CITY OF CONWAY, ARKANSAS PLANNING COMMISSION

February 17, 2026 • 5:30pm • 1111 Main Street

A. Request for preliminary plat approval of 51 Southerland Rd (SUB-1225-0148)

A. Request for conditional use permit to allow up to 12 dwelling units/acre in an R-2 zoning district for property located at 3 Susan Ln (CUP-0425-0056)

PRELIMINARY PLAT
OF
BEAR CROSSING
CONWAY, FAULKNER COUNTY, ARKANSAS
2/5/26
ZONED: 'A-1'

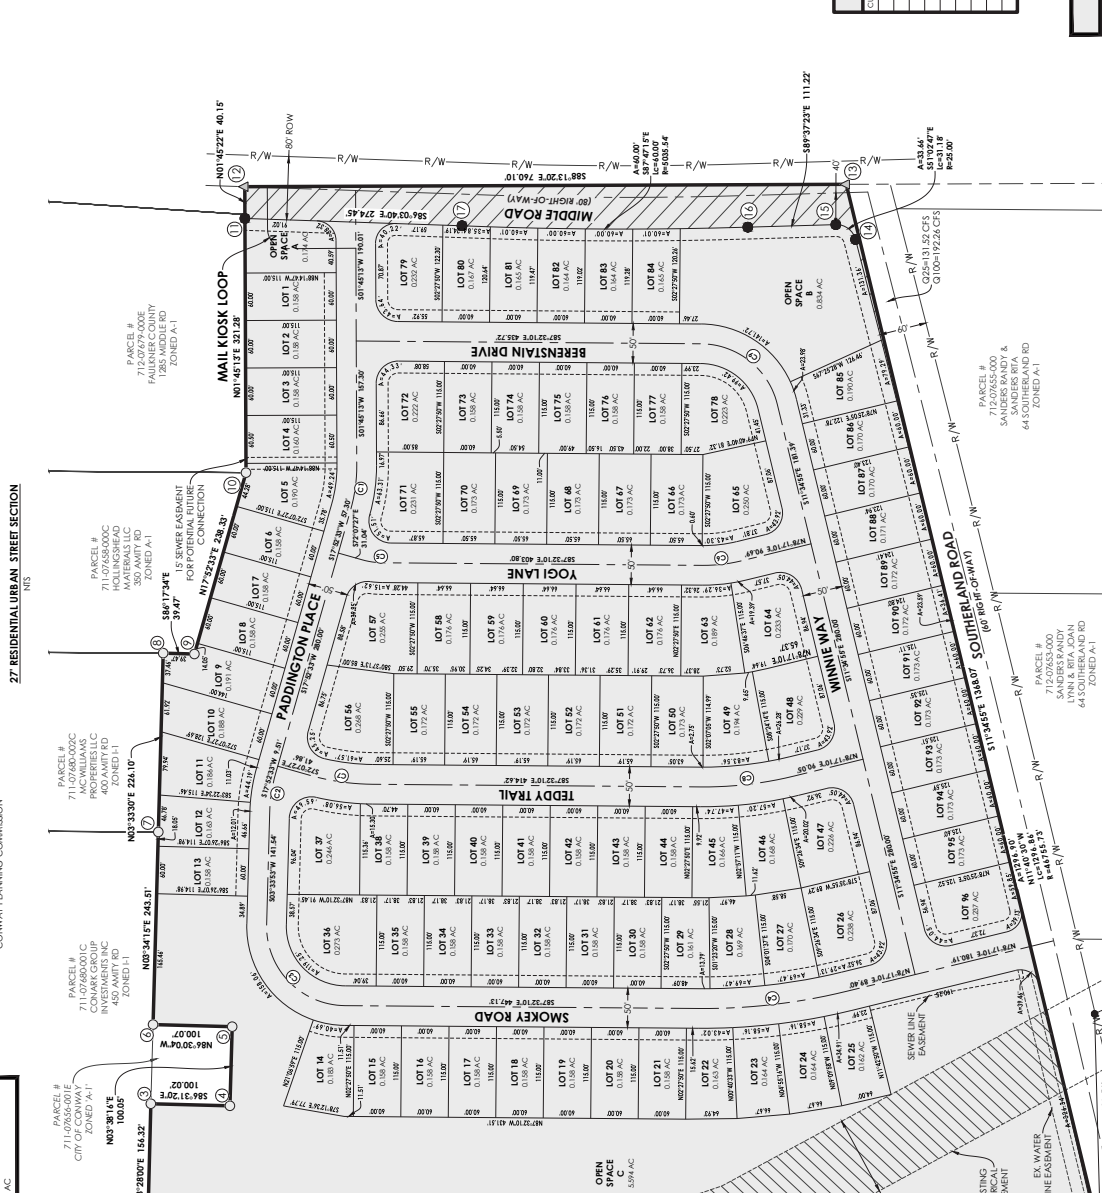
- Open Space Tract B is unbuildable and must be placed in a recorded drainage easement and referenced on the plat.
- Open Space Tracts A and C are also unbuildable and must be referenced as such on the plat.

- All lots meet the criteria for lot width, depth, and area for standard R-1 lots.
- Any lots without 60' of street frontage are along curving street frontages and the side lot lines are separated by the minimum lot width required at the building line, per R-1 standards.

CORRECTIONS NEEDED ON THE PLAT

1. Corrections as noted on the Preliminary Plat and Street & Drainage Plans as provided to the applicant.

3. Fire hydrants must be placed so that the furthest point of a lot in a residential subdivision is not more than 600 feet from the hydrant located on the same street. Variances must be approved by the Planning Commission and Fire Chief.

6. Drainage easements as required by the City Engineer are needed.
7. The applicant shall establish a planting screen easement of at least ten feet along the portions of each lot abutting Middle Road and Southerland Road. This easement shall be shown on the preliminary plat prior to being signed by the Planning Commission chairman.
